### APPEAL SUMMARY

<b>Appeal ID:</b> 16062	<b>Project Address:</b> 318 NE Couch St
<b>Hearing Date:</b> 11/1/17	<b>Appellant Name:</b> Tom Jaleski
<b>Case No.:</b> B-014	<b>Appellant Phone:</b> 5034885651
<b>Appeal Type:</b> Building	<b>Plans Examiner/Inspector:</b> John Cooley, Amit Kumar
<b>Project Type:</b> commercial	<b>Stories:</b> 5 <b>Occupancy:</b> B, M, S <b>Construction Type:</b> III-A
<b>Building/Business Name:</b> Block 76W	<b>Fire Sprinklers:</b> Yes - Throughout
<b>Appeal Involves:</b> Reconsideration of appeal	<b>LUR or Permit Application No.:</b>
<b>Plan Submitted Option:</b> pdf [File 1] [File 2] [File 3] [File 4]	<b>Proposed use:</b> Commercial Building

**Block 76W**

**CLT Floor EJ Letter**

**Figure 1: Proposed floor assembly at the intersection between floor and non-load bearing exterior wall.**

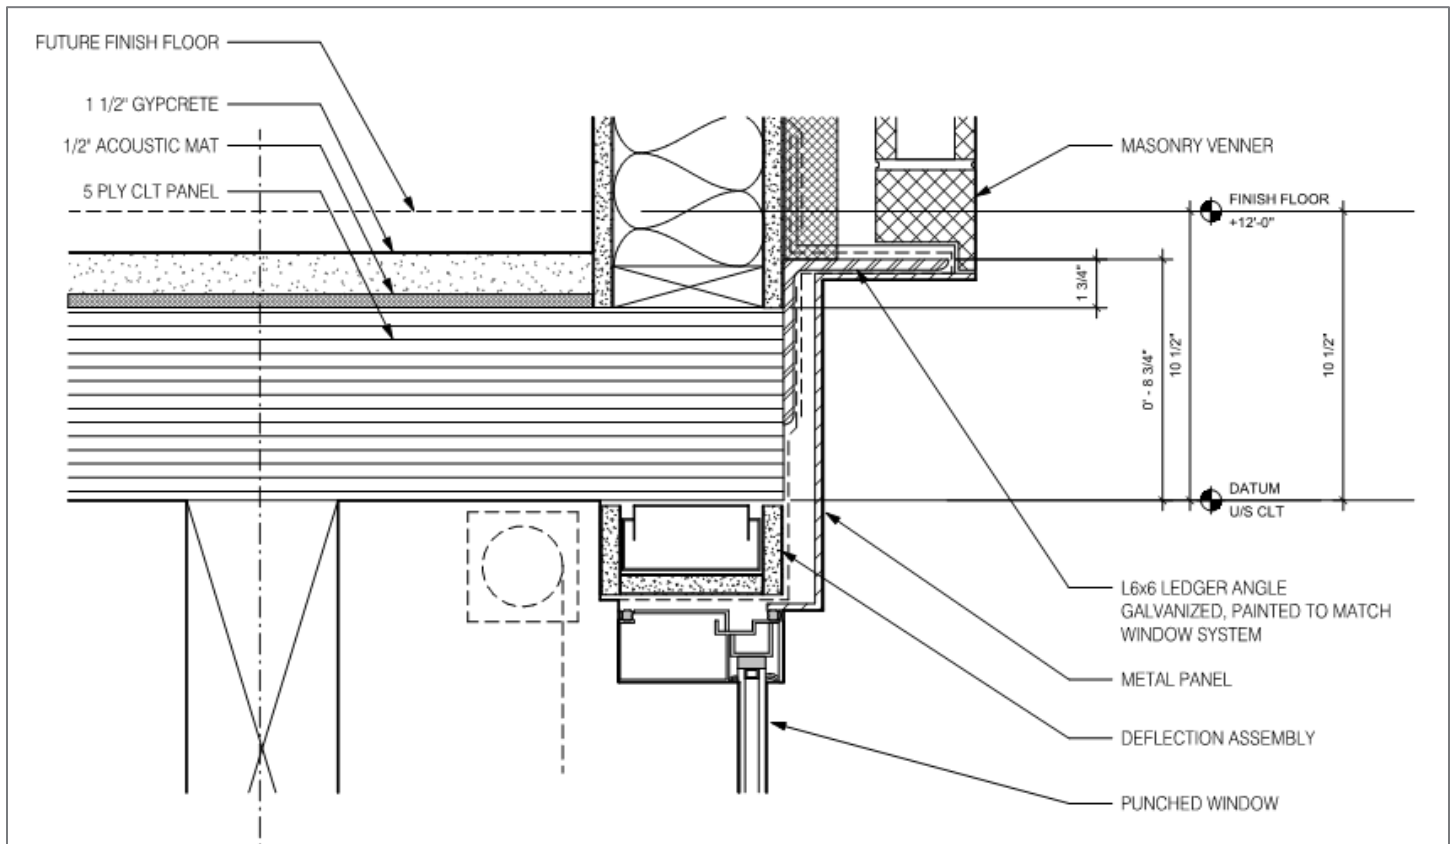
**Code Section** OSSC table 601, 602.3, 715.4

<b>Requires</b>	<p>Table 601</p> <p>The floor construction and associated secondary members are required to provide minimum 1 –Hour fire resistance protection in a type III A building.</p> <p>§ 602.3</p> <p>The exterior walls are of noncombustible materials and the interior building elements are of any material permitted by this code.</p> <p>§ 715.4</p> <p>Where fire resistance-rated floor or floor/ceiling assemblies are required, voids created at the intersection of the exterior curtain wall assemblies and such floor assemblies shall be sealed with an approved system to prevent the interior spread of fire. Such systems shall be securely installed and tested in accordance with ASTM E2307 to provide an F-rating for a time period at least equal to the fire resistance rating of the floor assembly.</p> <p>Exception: Voids created at the intersection of the exterior curtain wall assemblies and such floor assemblies where the vision glass extends to the finished floor level shall be permitted to be sealed with an approved material to prevent the interior spread of fire. Such material shall be securely installed and capable of preventing the passage of flame and hot gases sufficient to ignite cotton waste where subjected to ASTM E 119 time-temperature fire conditions under a minimum positive pressure differential of 0.01 inch (0.254 mm) of water column (2.5 Pa) for the time period at least equal to the fire-resistance rating of the floor assembly.</p>

The proposed floor assembly intersects a non-load bearing and non-rated exterior wall. The assembly is analyzed for fire resistance in accordance with chapter 7, § 715.4. A char rate analysis for the 5-ply Cross-Laminated Timber horizontal assembly is performed. See attached engineering judgement analysis report (EJ) for details.

**Alternate one hour floor / ceiling assembly with engineering analysis: Granted provided structural calculations are found to be acceptable during plan review.**

### Level 3 Worst - Case Span Conditions

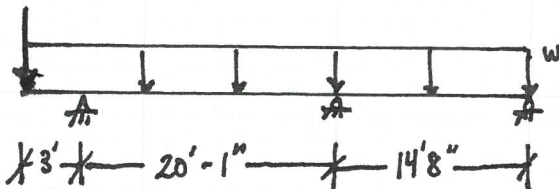
- a. Refer to the response to comment #3 & #4 for further explanation.
- 3) ***The proposed load combination (noted in comment #2) may not be consistent with the NDS method that already significantly increases the strength of the wood member. It is not clear in the code language or commentary if a reduced live load has already been considered by NDS when providing the significant strength increase. It is premature to accept the new load combination until the NDS has had a chance to review the reduced live load and possibly adjust the strength increase. The standard of practice has been to use full live load in combination with the 2.85 increase allowed in bending stresses in the NDS.***

- a. The char capacities ( $M_{Rfire}$  and  $V_{Rfire}$ ) noted on page 1 of the calculations exceed the maximum moment and shear demand ( $V$  and  $M$ ) for the full D+L combination for all configurations noted on the remaining calculation pages. Therefore, even if the "catastrophic event" case with reduced live loading is not considered, the CLT panels remain structurally adequate. Note that although the NDS permits the 2.85 multiplier for bending stress, it does not
